MID SUSSEX DISTRICT COUNCIL

Planning Committee

DM/19/3357

**HIGH TREES 41 HICKMANS LANE LINDFIELD HAYWARDS HEATH
REPLACEMENT DWELLING.
MR AND MRS J BURROWS**

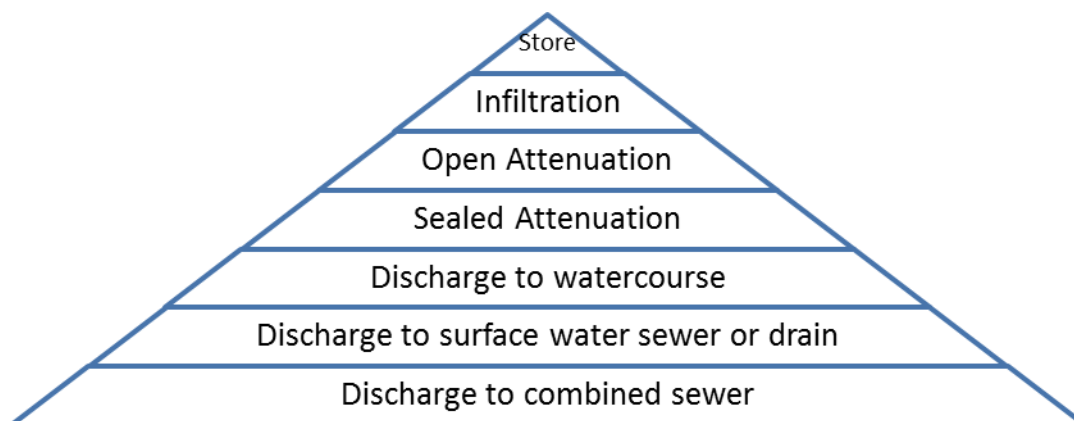
A surface water sewer is located beneath the footpath which runs along the southern boundary of the site. Analysis using our plans suggests this plan may be approximately 4m from the existing dwelling.

At this time we will require the following further information:

- Details showing the location of the proposed development in relation to the public surface water sewer.
- Evidence of communication with Southern Water regarding the proposed distance between sewer and proposed development.

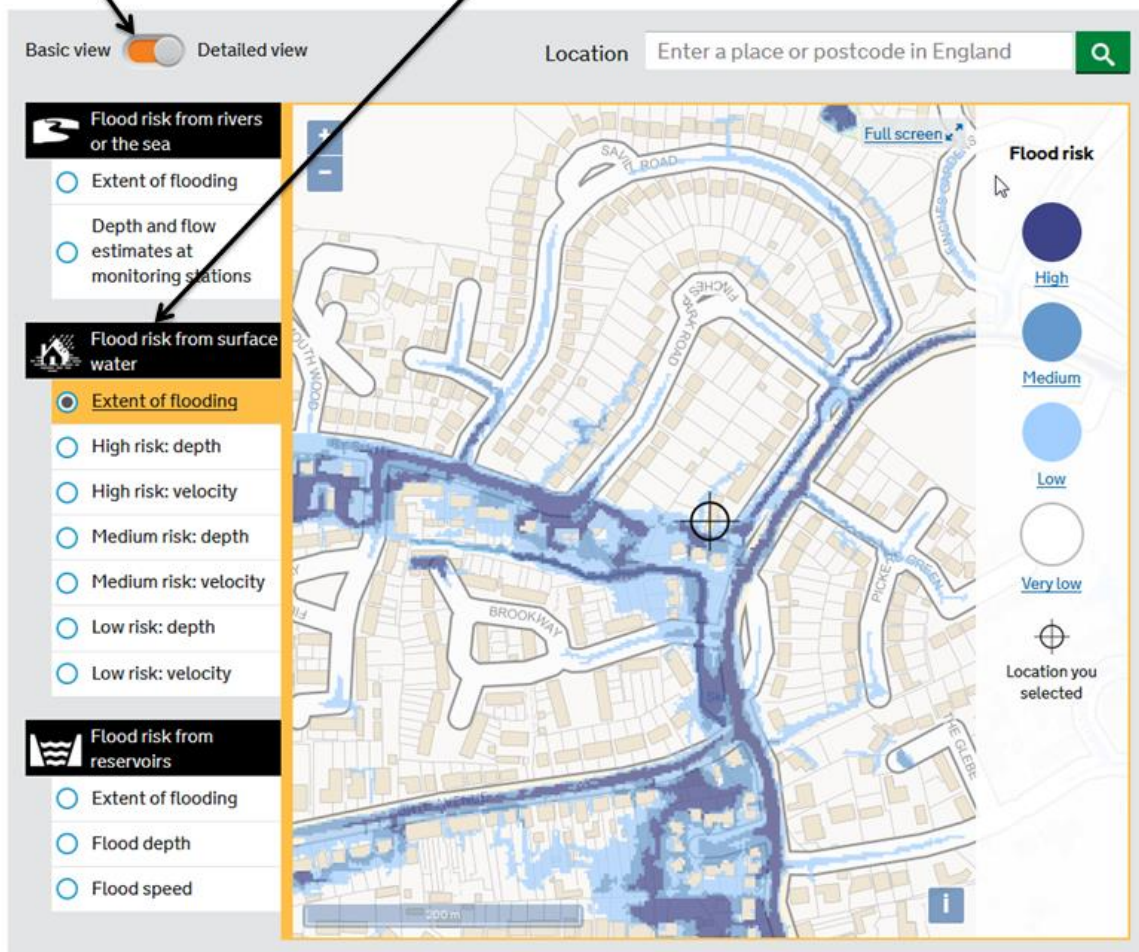
However, thank you for your document 'The On Site flood Risk Considered' which I have looked at and have the following comments to make;

In section 3.07 you state that the Flood Risk from Surface Water is very low but there are no paragraphs within the document that have actually dealt with the surface water flood risk. For your information I have shown an extract from the gov.uk website and provided a link to their long term flood risk page. You can find the flood risk for any property in England by simply entering a postcode and then viewing the flood risk information. I have highlighted the information you need to toggle on to get what you need. This long term flood risk map shows there is a **low risk of flooding** on parts of the application site as concluded in your Flood Risk Assessment, however, the site sits adjacent to a high flood risk area. Climate change may well increase flood extents in the future and this is why we have requested that you should consider flood resistance and resilience measures for the property. You should at least be informing your clients of this information so they can be aware of the risk themselves.

Now that the flood risk for this development has been assessed and you are aware of the risk, I have no requirement for further information related to flood resistance and resilience.
